## ATTACHMENT A: OPERATION WITH REACTOR COOLANT PUMP POWER MONITORS

### I. CHANGE REQUEST

These changes address the current reactor refueling for Cycle V. The changes are supported in BAW-1767, Crystal River Unit 3 - Cycle 5 Reload Report, March 1983. Item II of this attachment lists the proposed Technical Specification changes.

FIGURE 2.1-2

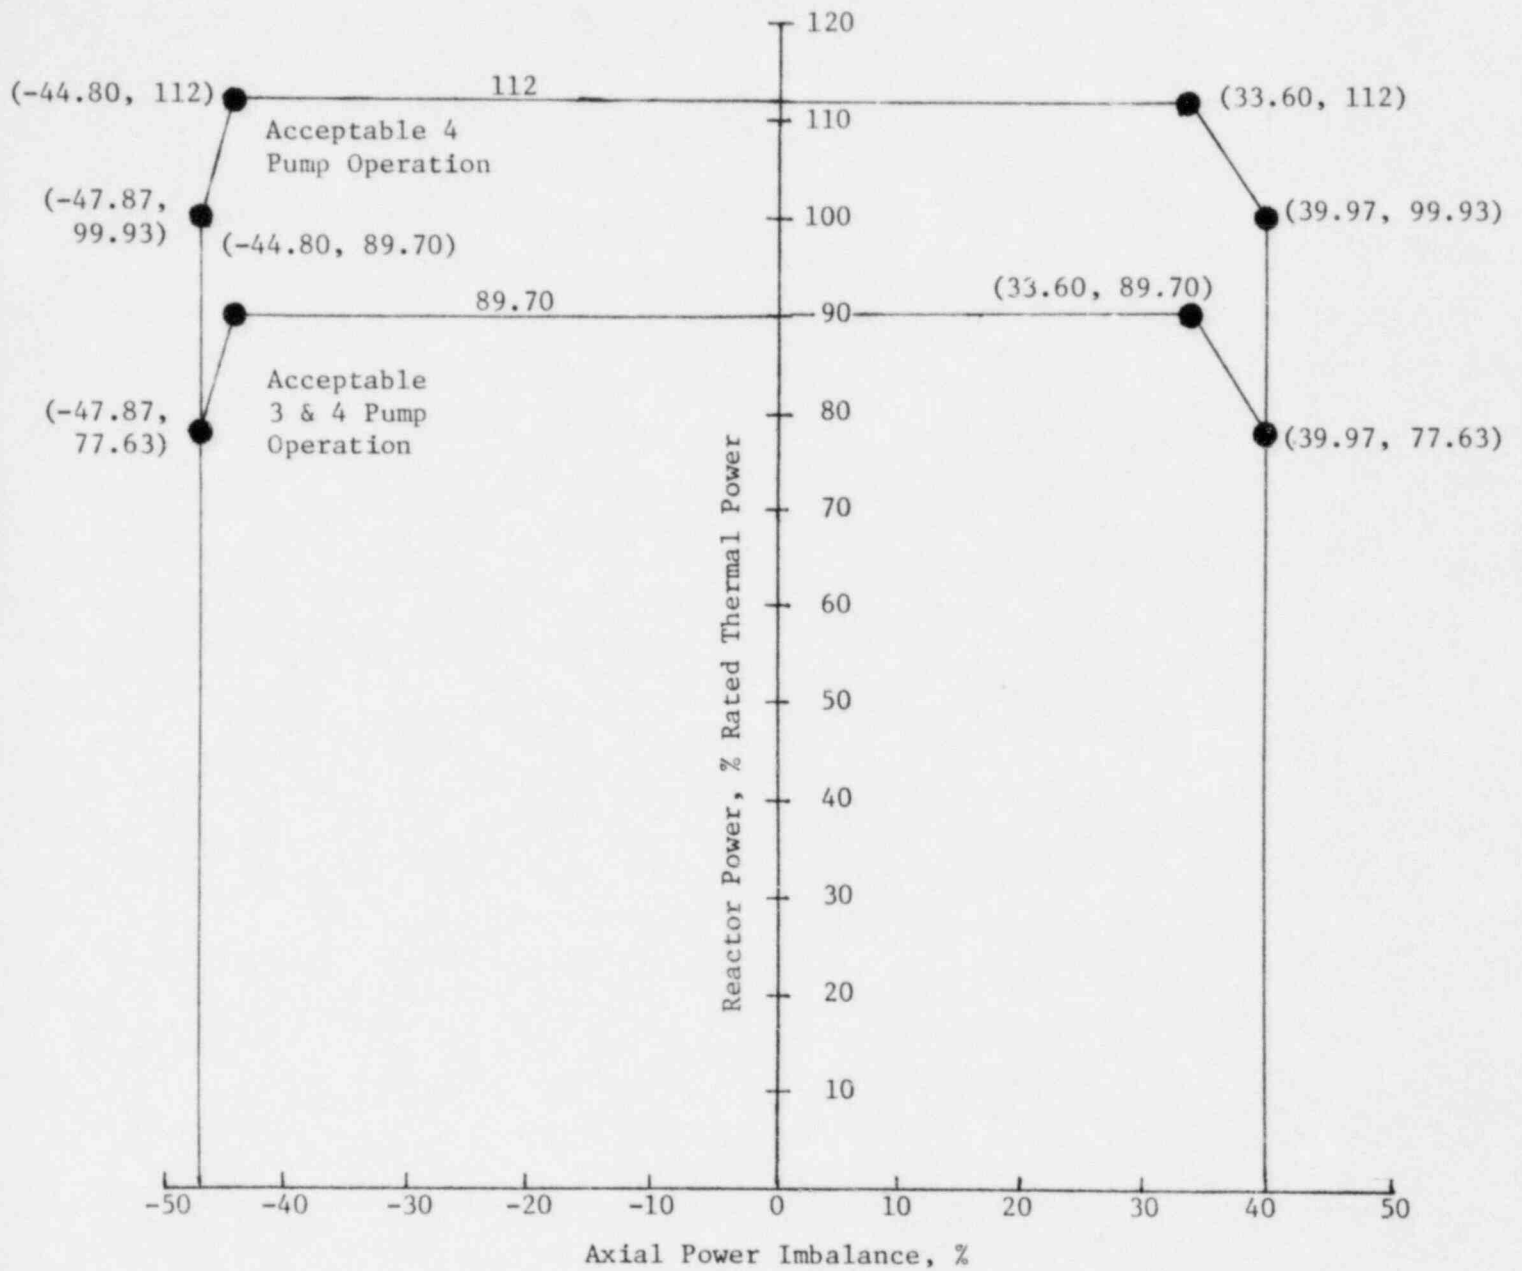
1. Reactor core safety limits and trip setpoints for reactor thermal power and axial power imbalance.
2. Minimum boric acid and borated water volumes.
3. Reactor Regulating rod group insertion.
4. Reactor axial power shaping rod group insertion.
5. Reactor axial power imbalance limits
6. Reactor Coolant Pump Power Monitor operability response time requirements.
7. Shutdown Margin Requirements (not supported by BAW-1767 but by Attachment E, Item II).

Crystal River Unit 3 will operate in Cycle V with 76 fresh fuel assemblies. The Cycle V core has been designed with an increased cycle lifetime of 460 effective full power days (EFPD) and the incorporation of burnable poison rod assemblies to aid in reactivity control. As stated in BAW-1767, certain Technical Specifications require revision due to these fuel and thermal characteristics changing.

FIGURE 2.2-1

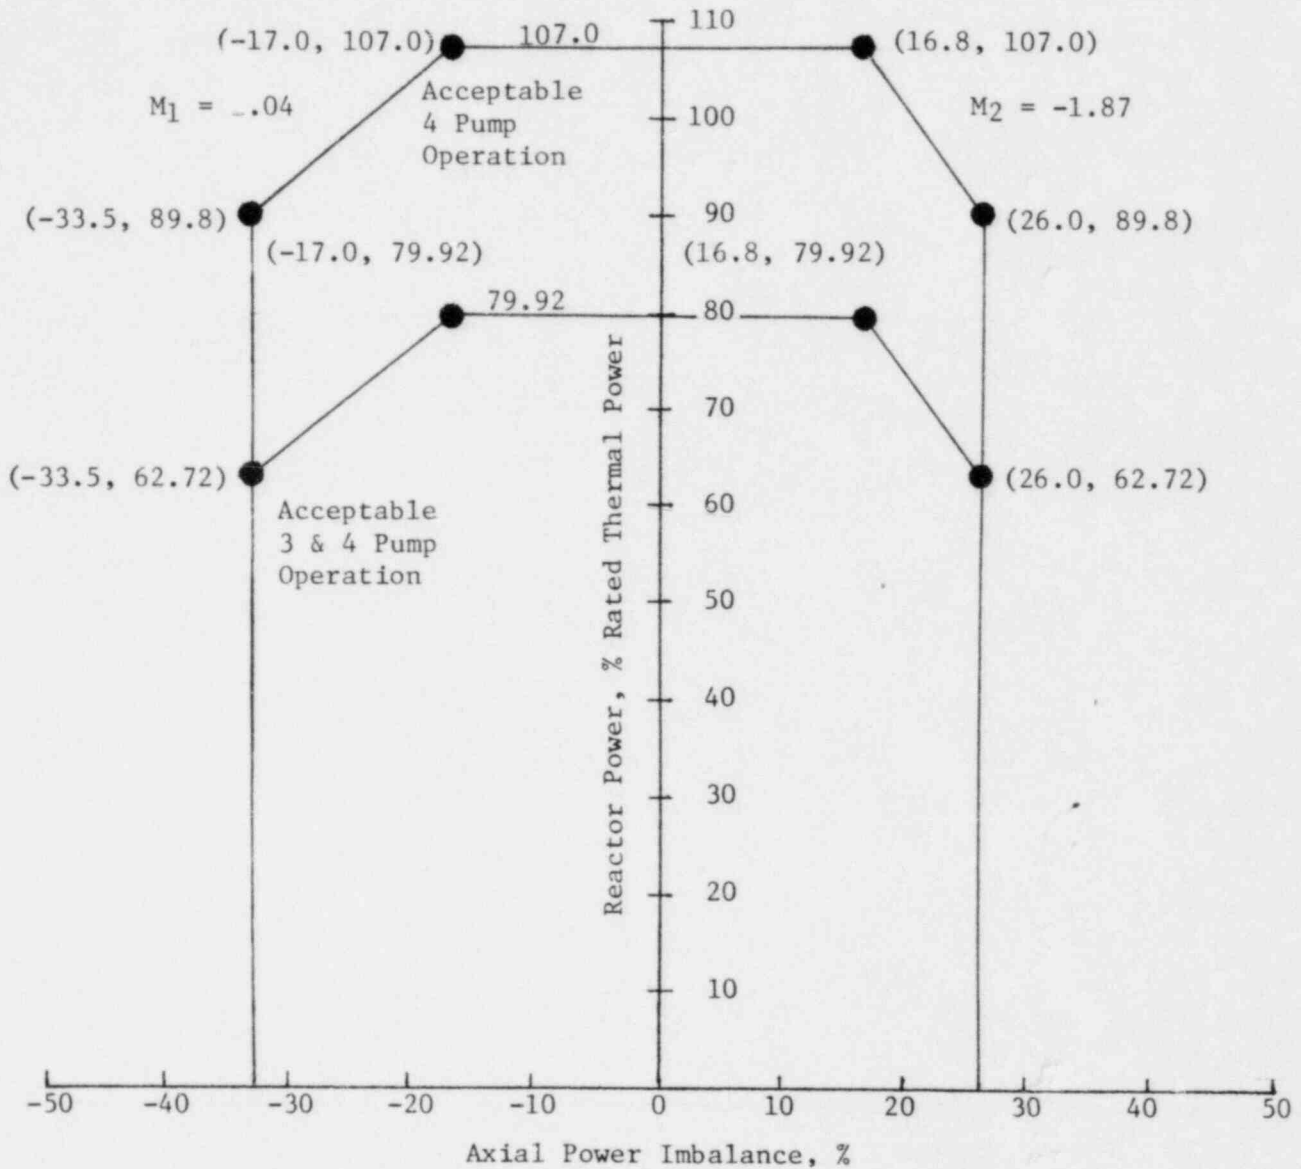
3. RCS Outlet Temperature - High	$\leq 618^{\circ}\text{F}$	$\leq 618^{\circ}\text{F}$
4. Nuclear Overpower Based on RCS Flow and AXIAL POWER IMBALANCE (1)	Trip Setpoint not to exceed the limit line of Figure 2.2-1	Allowable Values not to exceed the limit line of Figure 2.2-1

FIGURE 3.1-1

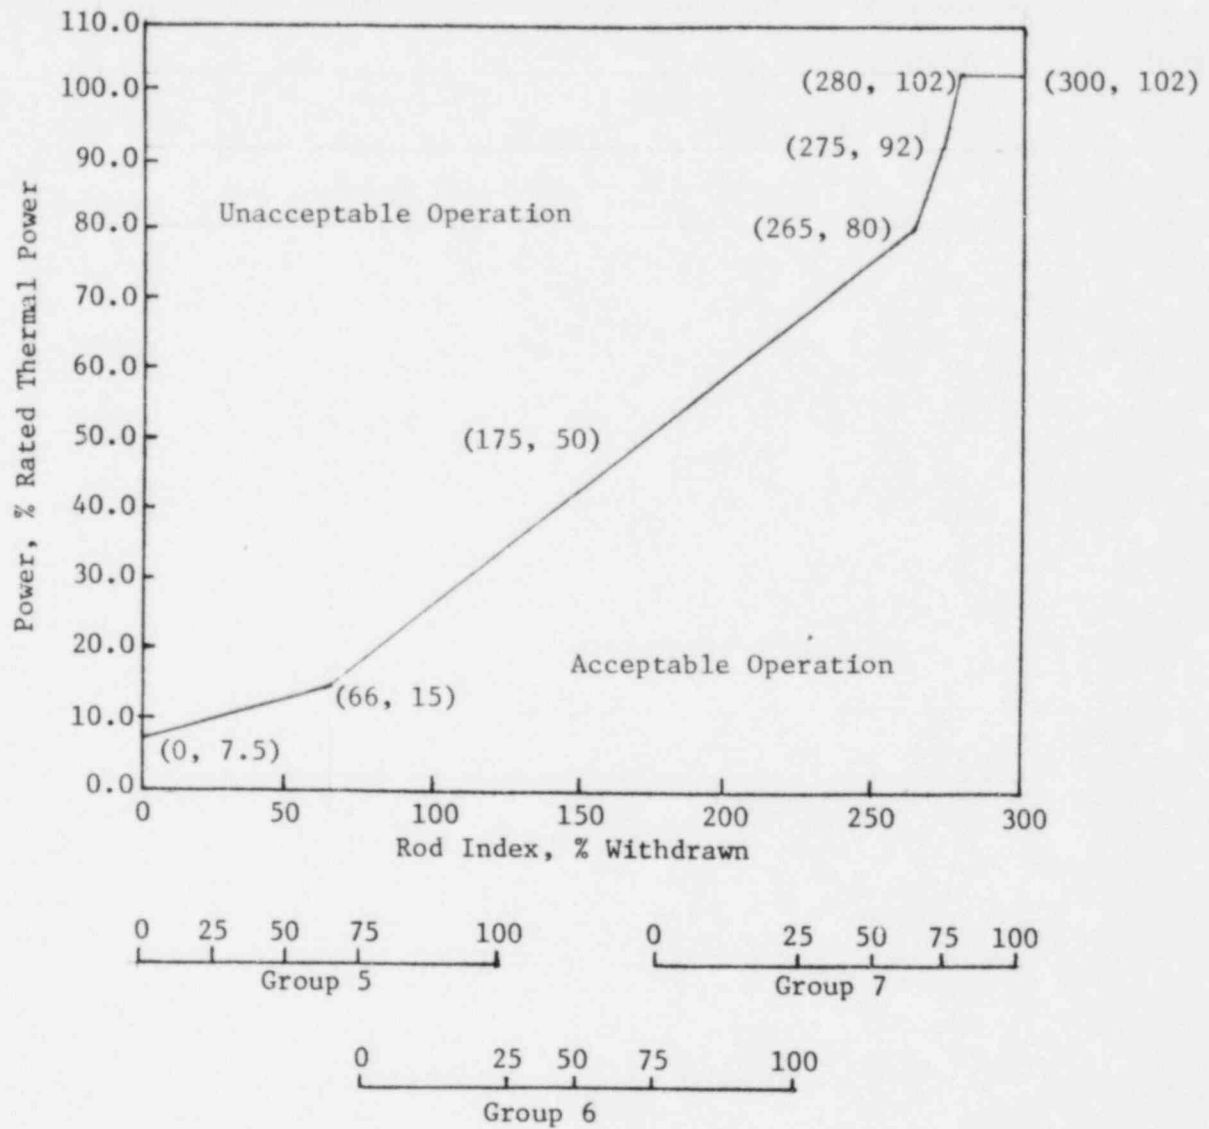
3.1.3.6 The regulating rod groups shall be limited in physical insertion as shown on Figures 3.1-1, 3.1-1a, 3.1-2, 3.1-2a, 3.1-3, 3.1-3a, 3.1-4 and 3.1-4a with a rod group overlap of  $25 \pm 5\%$  between sequential withdrawn groups 5 and 6, and 6 and 7.
